GENERAL

This addendum forms a part of the Contract Documents and modifies the original Bidding Documents dated February 2024 and consists of pages AD1-1 through AD1-3, PSSB Data As-Built and PSSB RCP As-Built. The following changes, additions and/or deletions shall be made to the following documents; all other conditions shall remain the same.

ITEM NO. I – RFI/CLARIFICATIONS

PATIENT SUPPORT SERVICES BUILDING
 UCD PROJECT NO. A/C 934990

011201

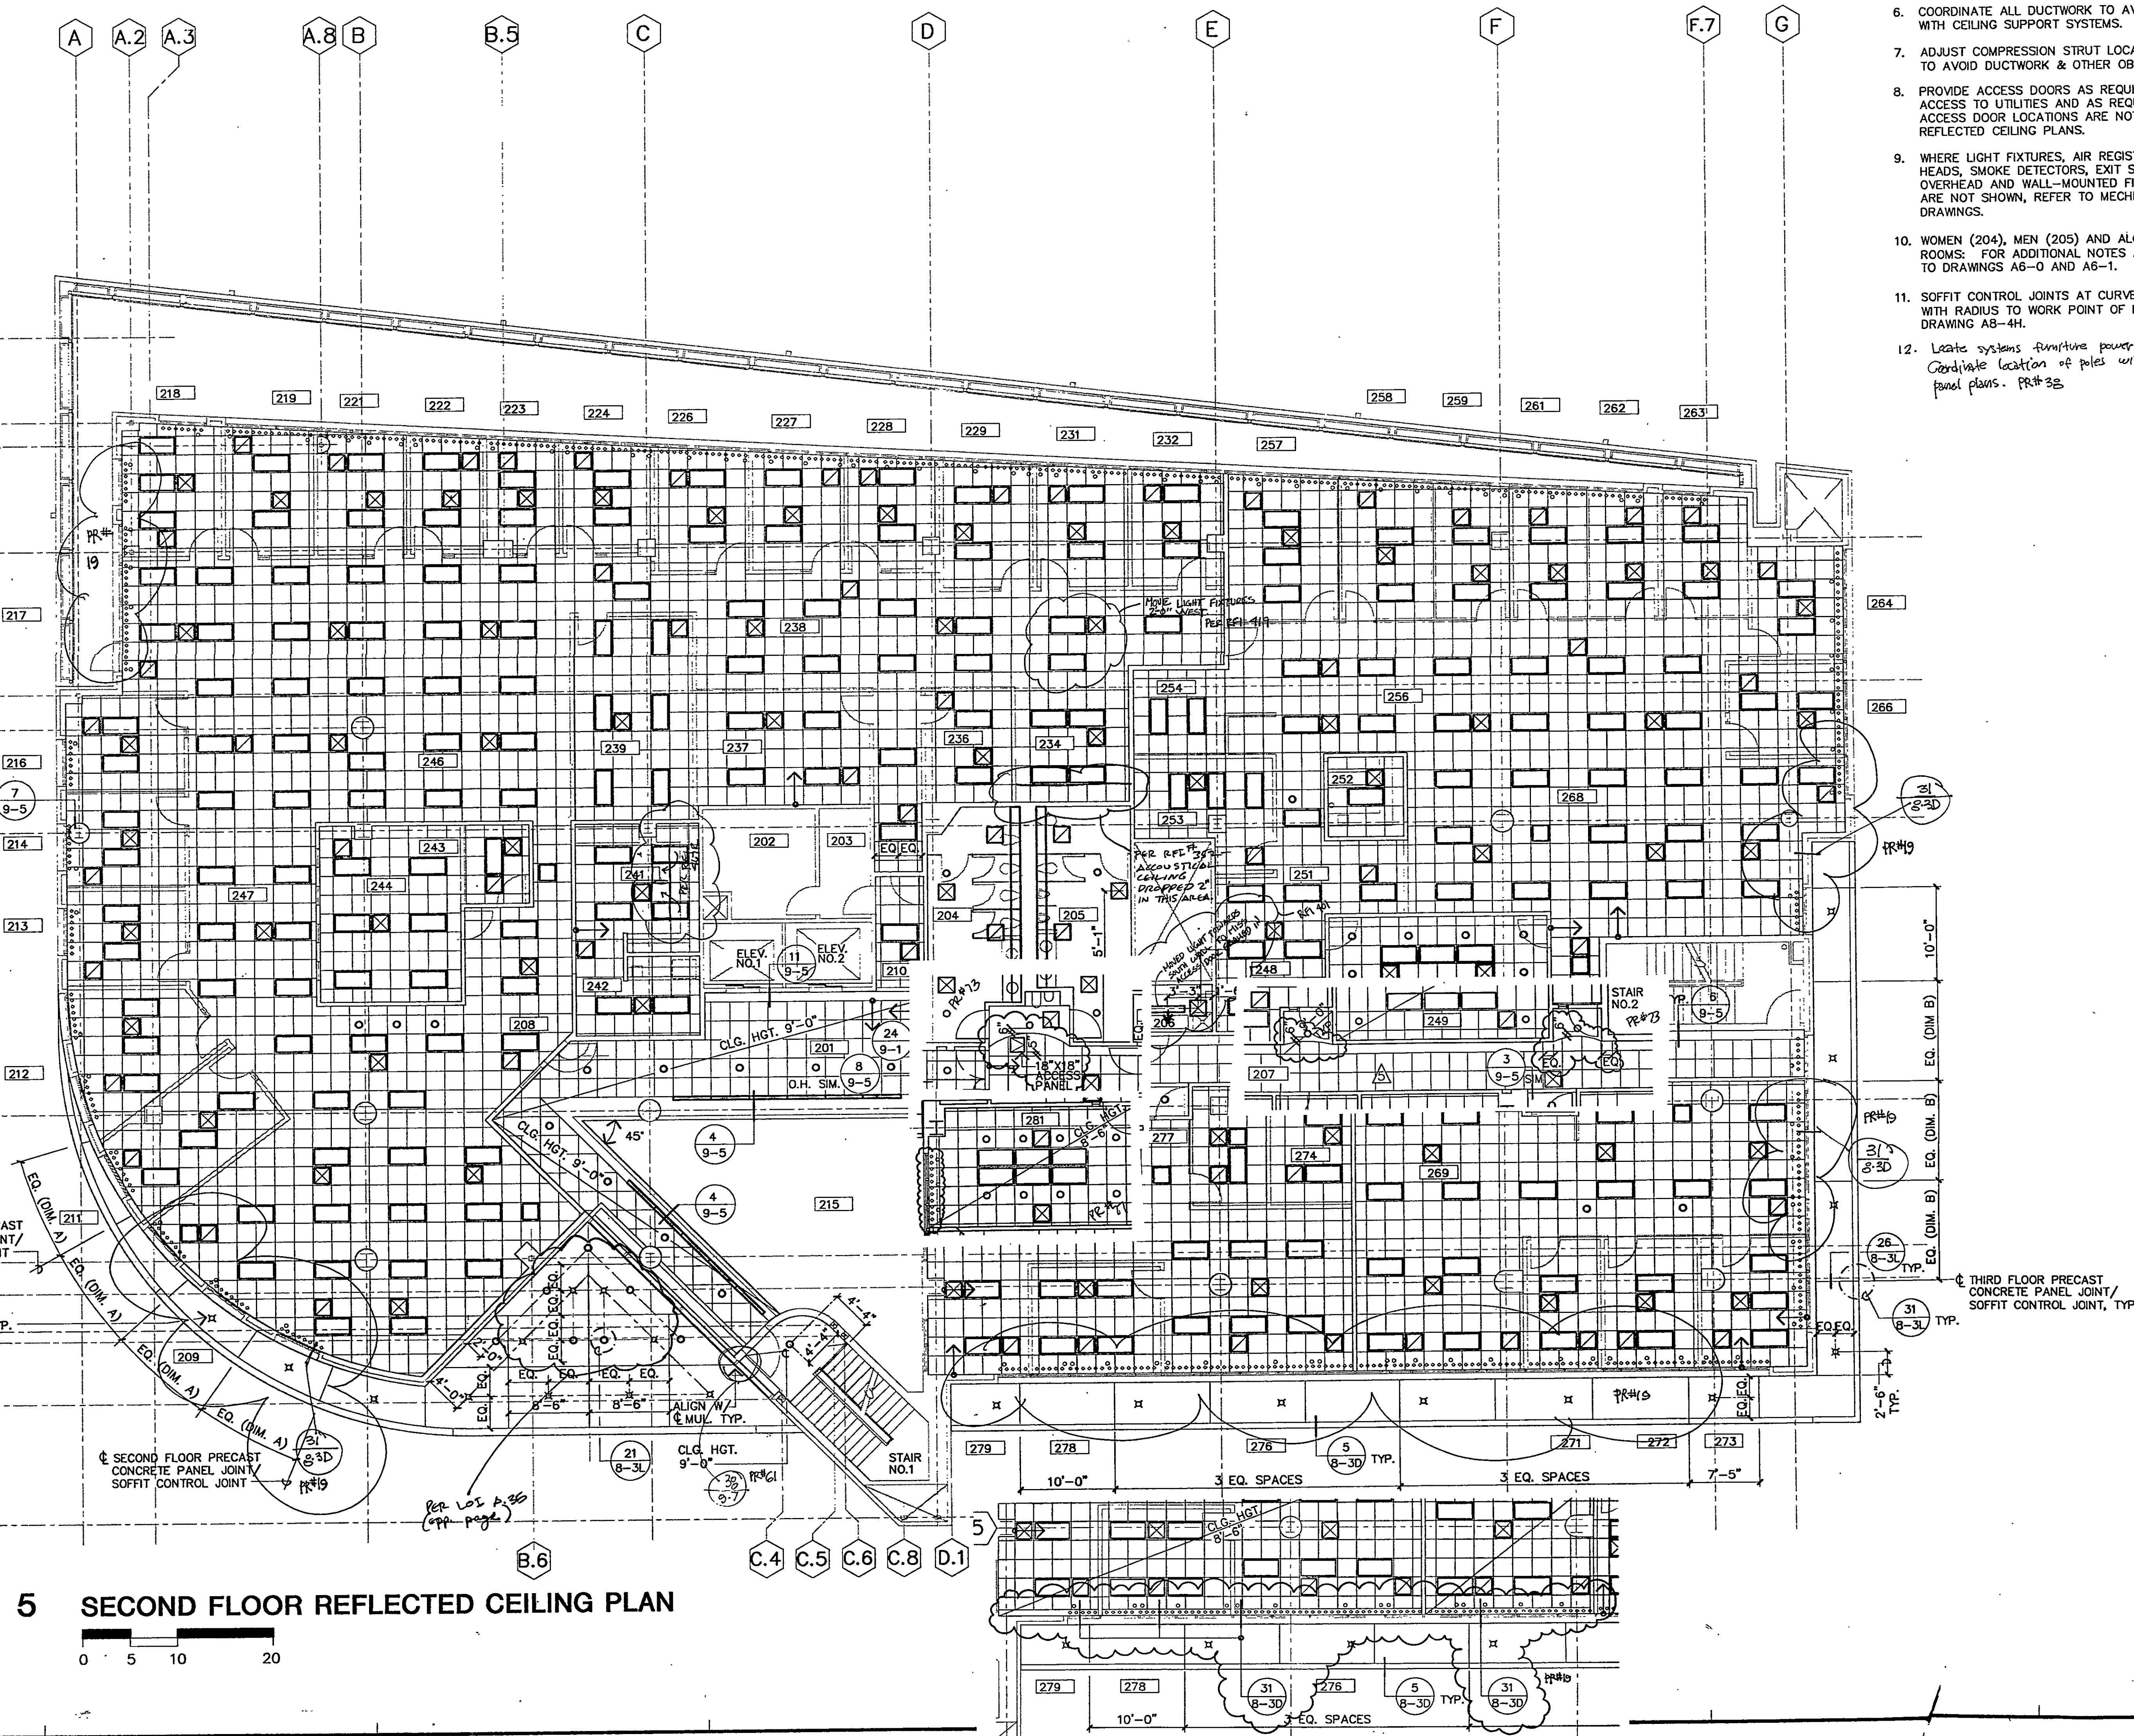
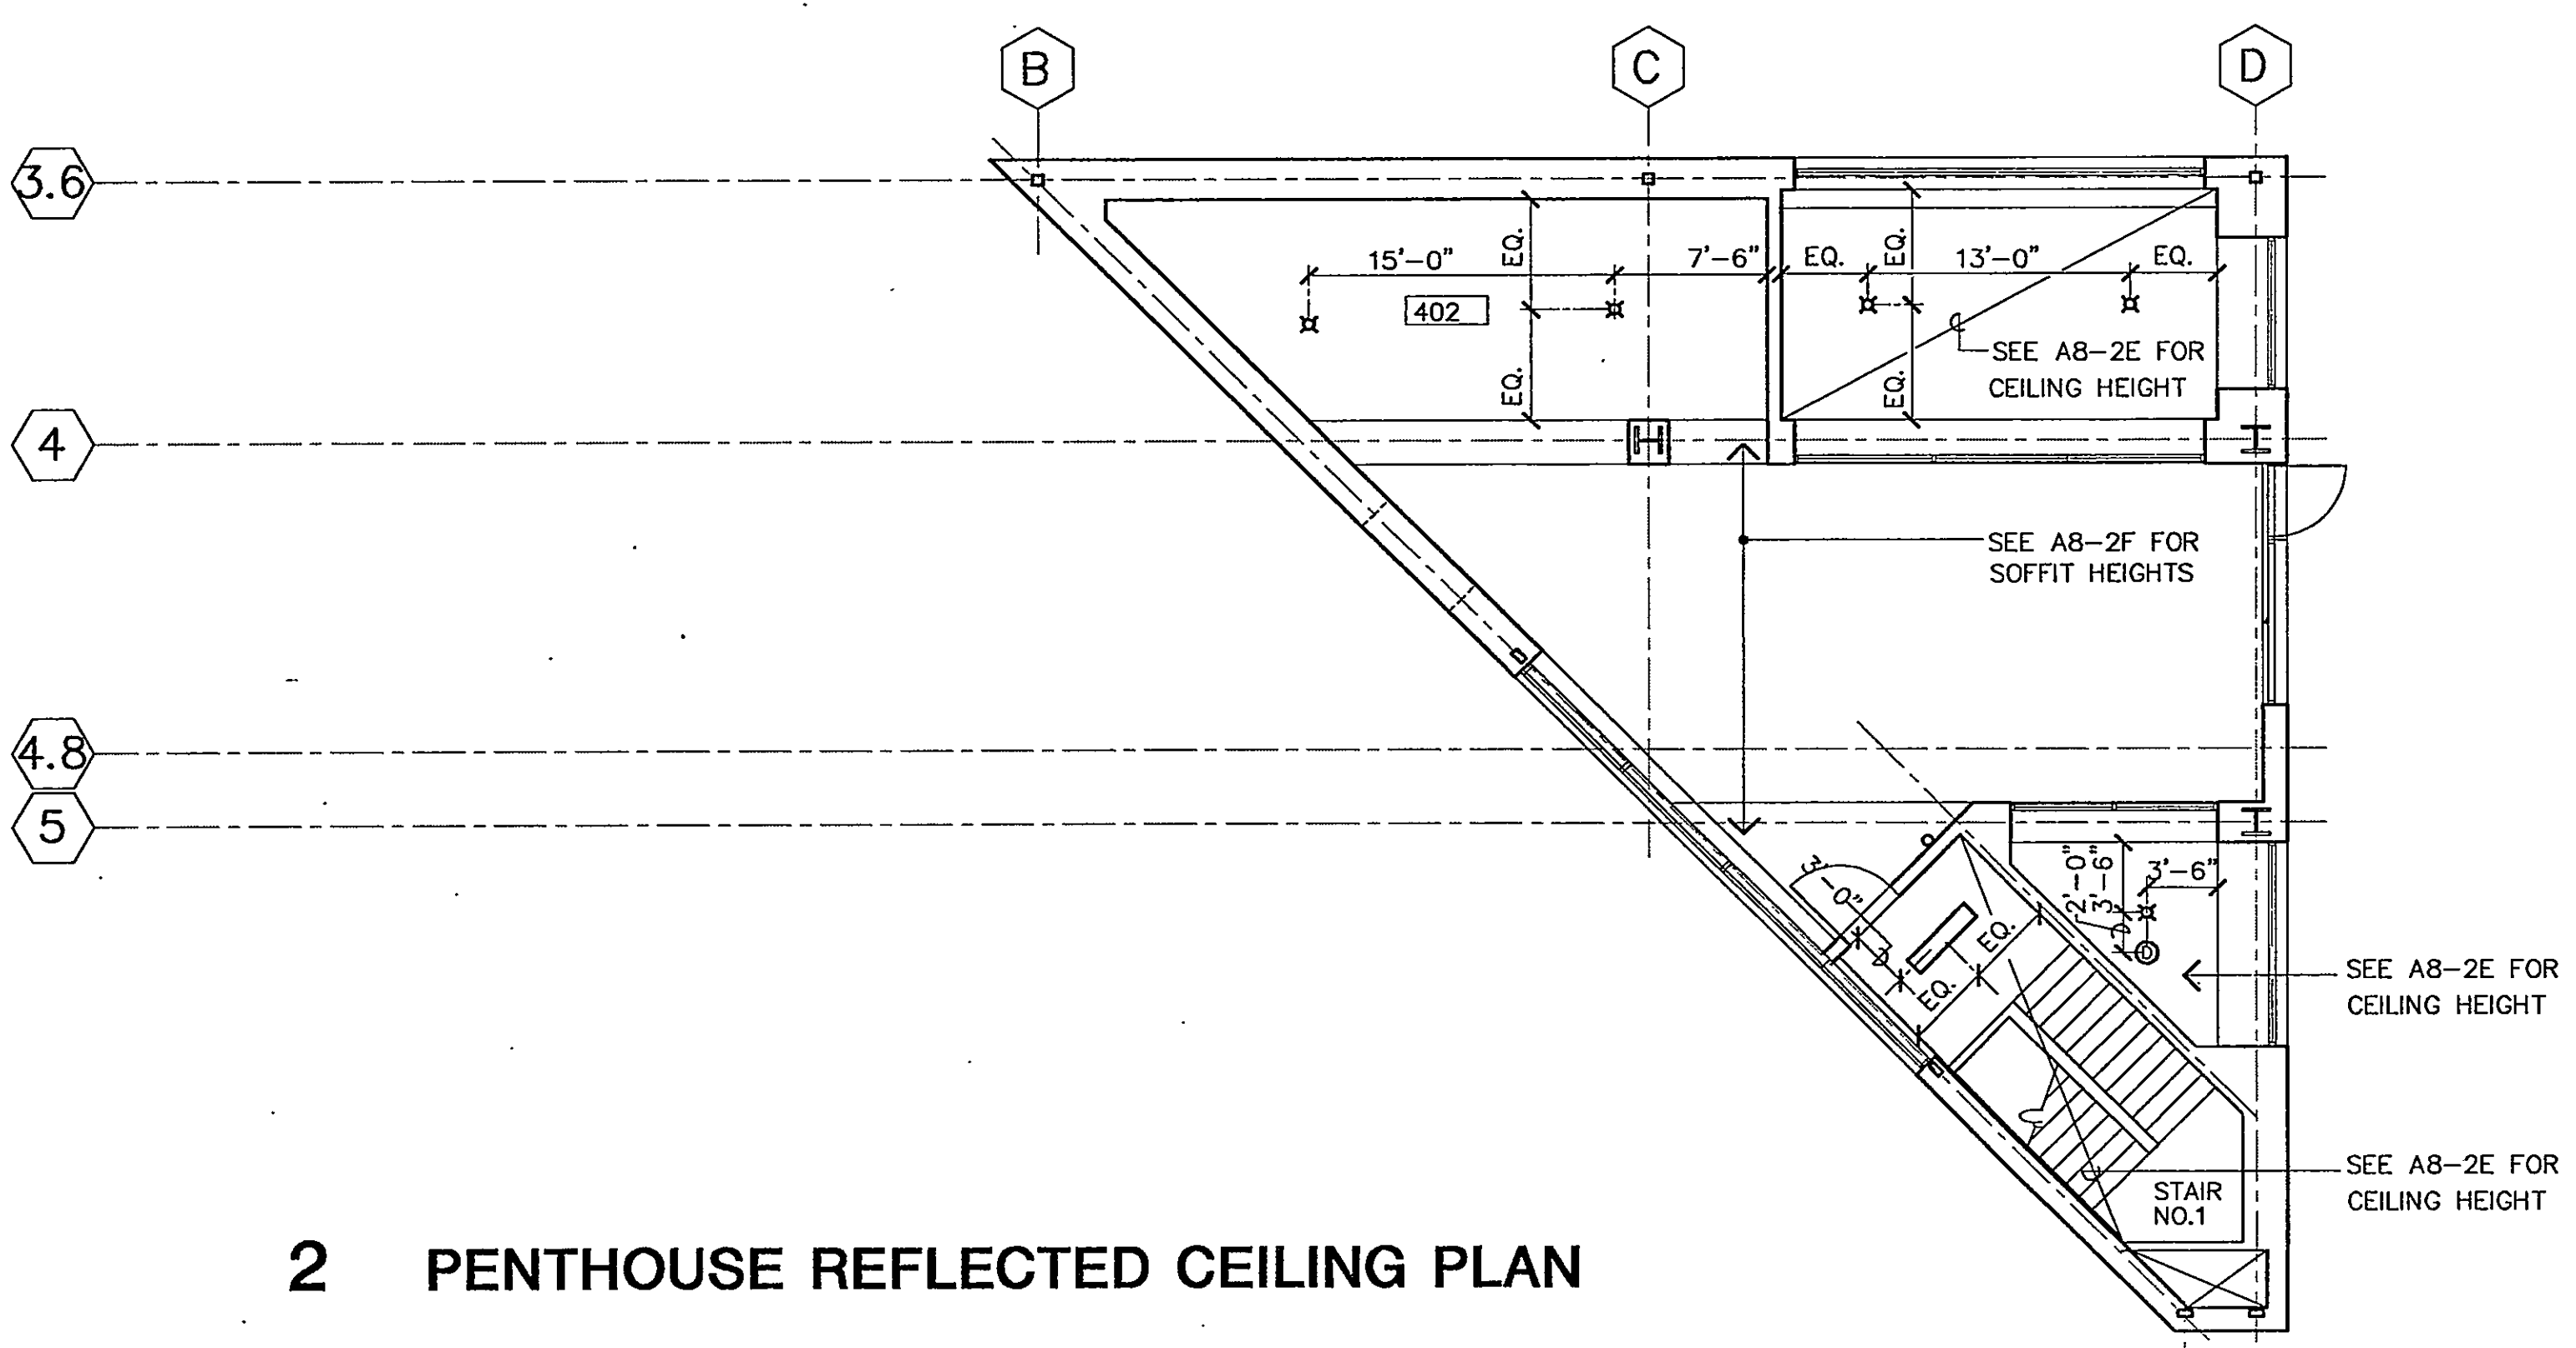
17. **Question:** Please confirm the ceilings on each floor are drop tiles in the areas where we will be required to access the ceiling.

18. **Question:** Please confirm the ceiling height on each floor is not higher than 15'.

Answer: See attached as built reflected ceiling plans. There are limited areas where a hard lid ceiling is present.

Answer: Confirmed. Caveat being the entryway atrium space. See reflected ceiling plan as built files for to reference extent of atrium space.
